Lots 302 Mandurah Road and 309 Kerosene Lane, Baldivis

Addendum for the LWMS

By Urbaqua

March 2018

Figure 9 - Conceptual Stormwater System

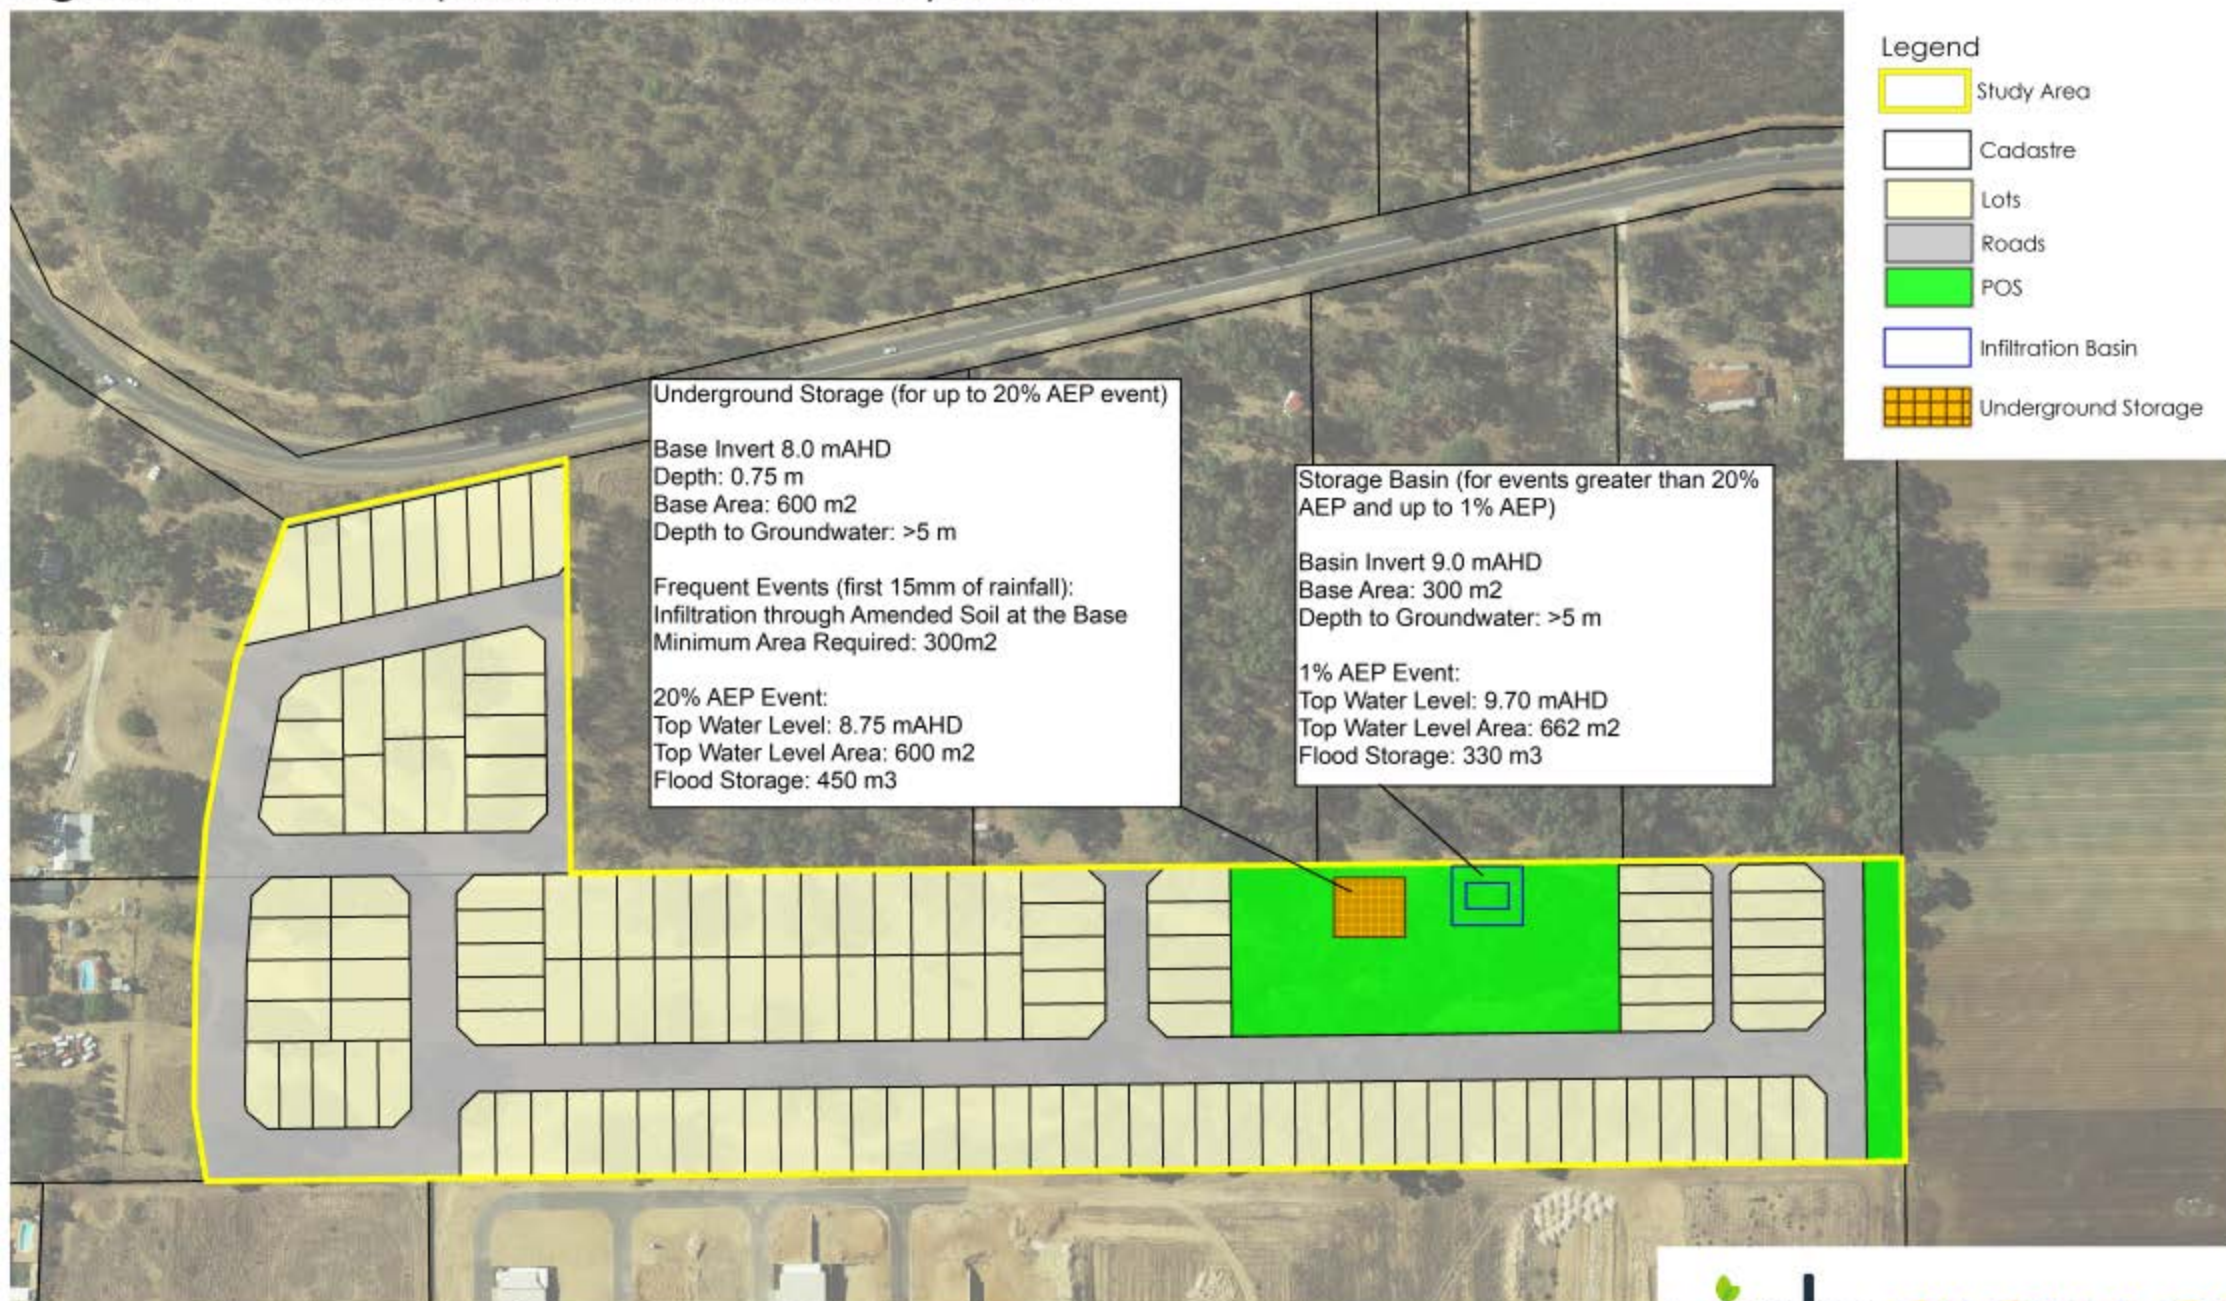
CoR	<p>Figure 9 has not been updated since the previous version of the LWMS and as such the information presented differs to that shown in Table 7. Figure 10 refers to an infiltration basin and area of inundation for the 1, 5 and 100 yr ARI. This should refer 1 EY, 20% and 1% AEP.</p> <p>Table 7 shows that the underground storage invert is the same as the storage basin invert of 9.0 mAHD. A conceptual cross section of the updated stormwater management configuration (underground storage and drainage basin) must be provided to demonstrate the intended design.</p> <p>A landscape concept is required to show how the stormwater management system will interact the POS design including existing vegetation/trees to be retained. The request for a Landscape Plan is outlined in Appendix A of the LWMS as a Better Urban Water Management (WAPC, 2008) requirement.</p>
DoW	<p>Diagrams indicated that the "1 yr ARI event" will be directed to surface bioretention area. All figures should be updated to reflect any revised stormwater runoff strategy.</p> <p>Please include a cross section of the proposed infiltration basin and include conceptual top water levels for all rainfall events, location and depth of amended soil, depth to groundwater and slope gradients. The cross section should indicate how the underground storage cells are integrated into the POS/stormwater runoff treatment system and detail preliminary dimensions, pipe connections and use of amended soils.</p>

Response	<p>Noted. Figures 9 and 10 had not been updated since the previous version of the LWMS.</p> <p>Hydrology and hydraulic modelling of the site has been undertaken with the latest IFDs and the infiltration rate of 5 m/day. Table 7 has been updated accordingly.</p> <p>Updated Figures 9 and 10 with a cross section as requested are provided in this addendum. A landscape concept is also provided in Attachment 3.</p>

ATTACHMENT 1: Groundwater Sampling Bore Location

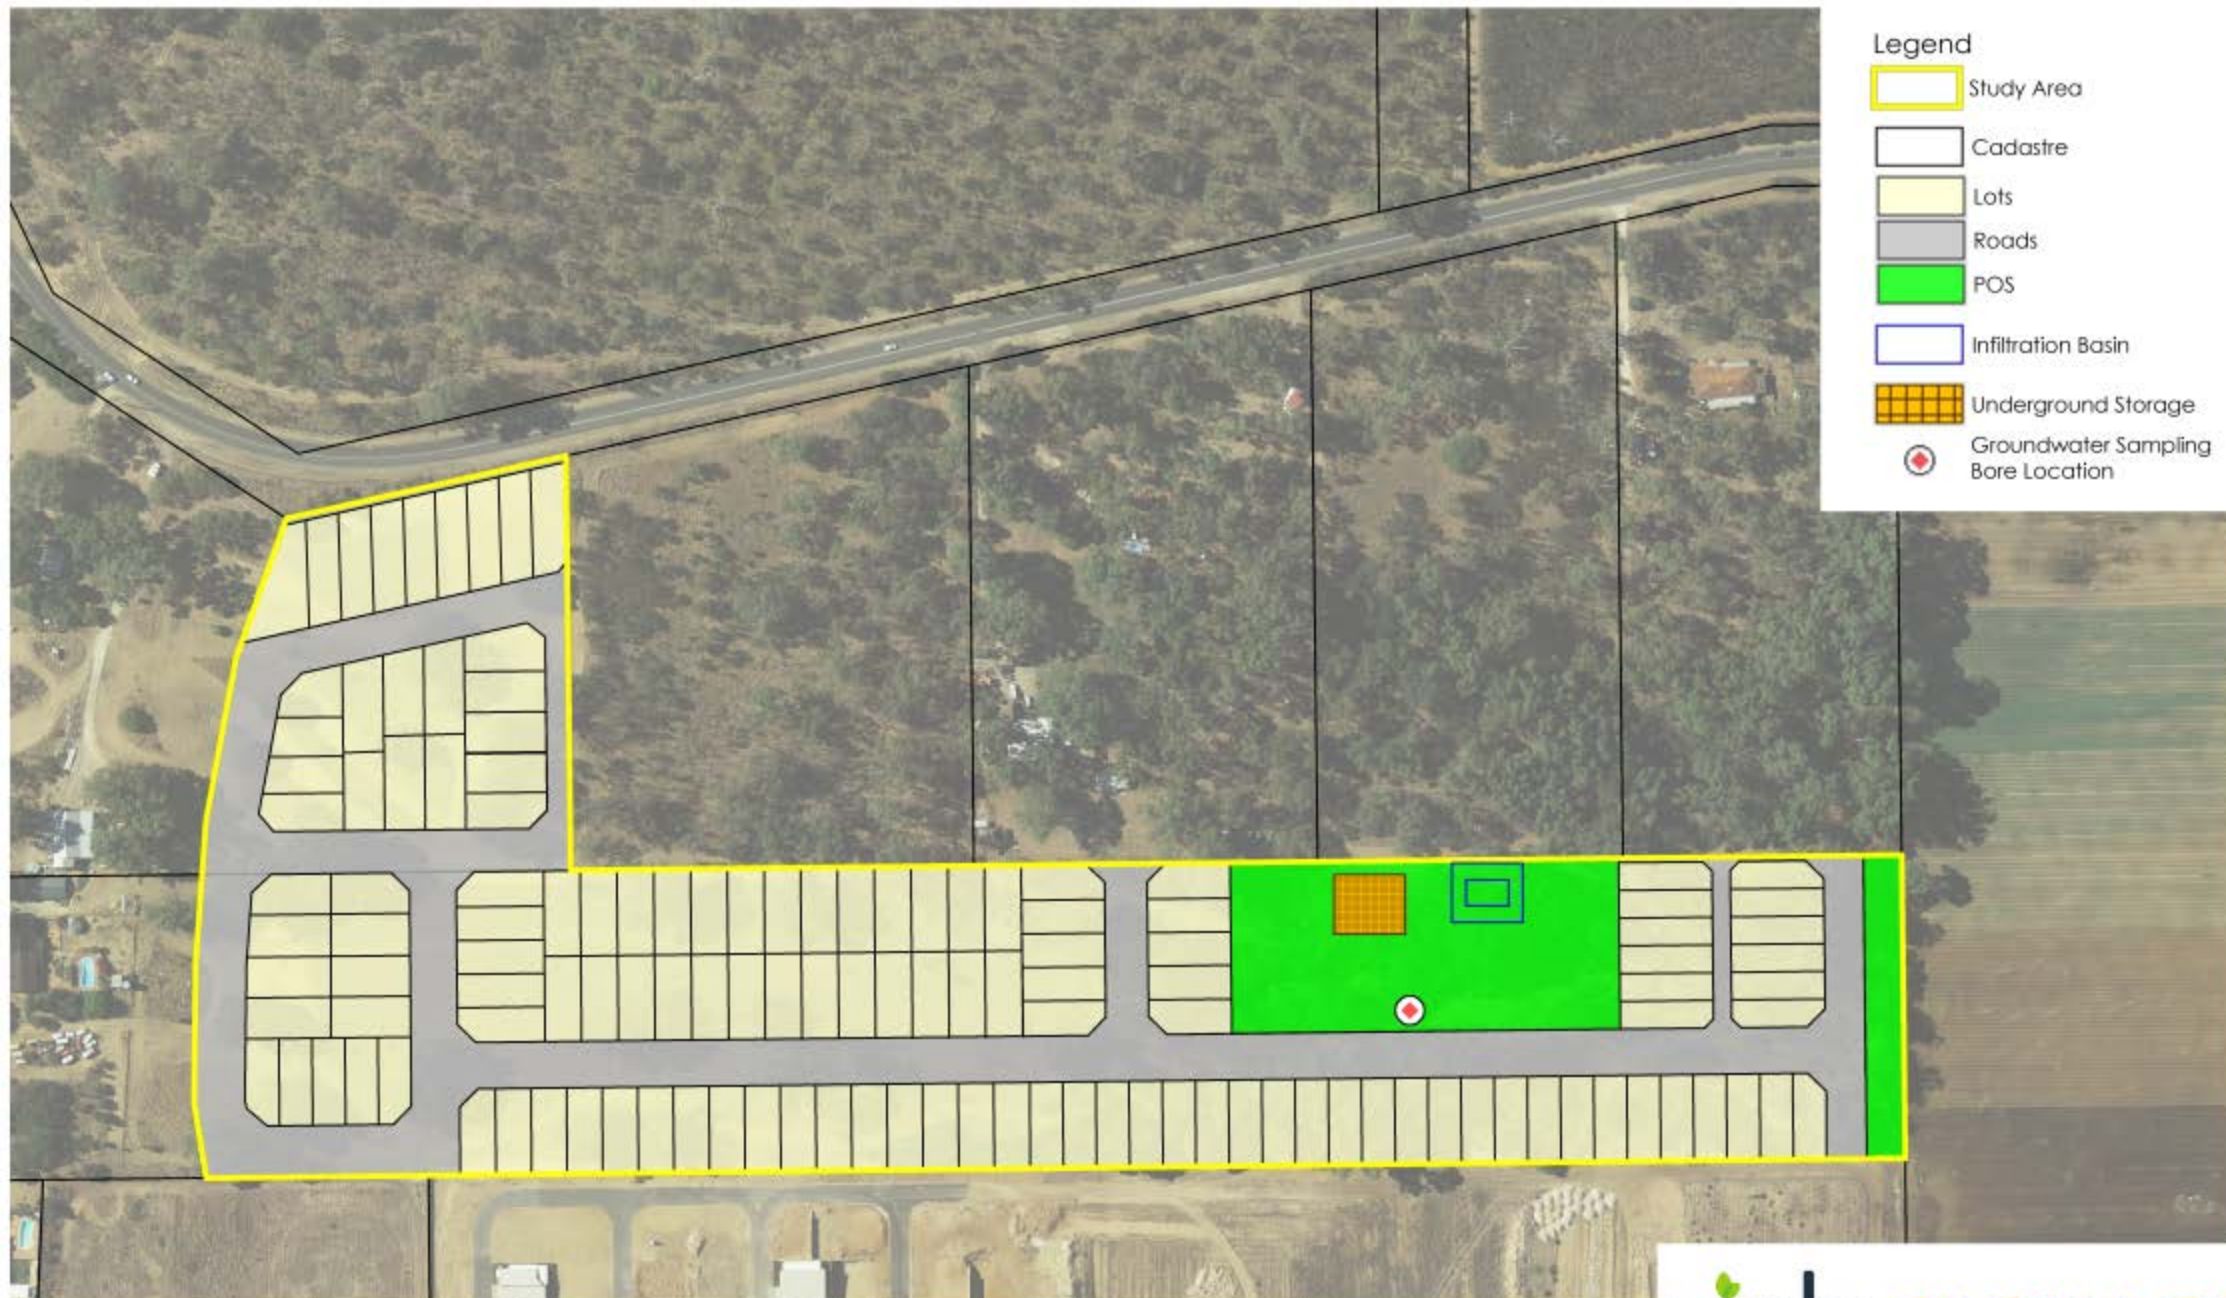
CoR	Response noted and site-specific groundwater monitoring data sighted. Was this bore installed in the future location of the POS? The LWMS must be updated to show the groundwater bore location on a figure and include the lithological bore log as Appendix. The conversion to TDS (mg/L) is unclear. The ANZECC (Section 9.2.10.2) recommended conversion factor of EC to TDS is (EC x 670 = TDS (mg/L)). This would equate to a site-specific TDS of 1541 mg/L.
DoW	-
Response	The Sampling bore was installed in the future location of the POS. The bore location is provided in this addendum. The TDS conversion has also been revised and provided.

The location of the bore is provided in Attachment 1 of this addendum.
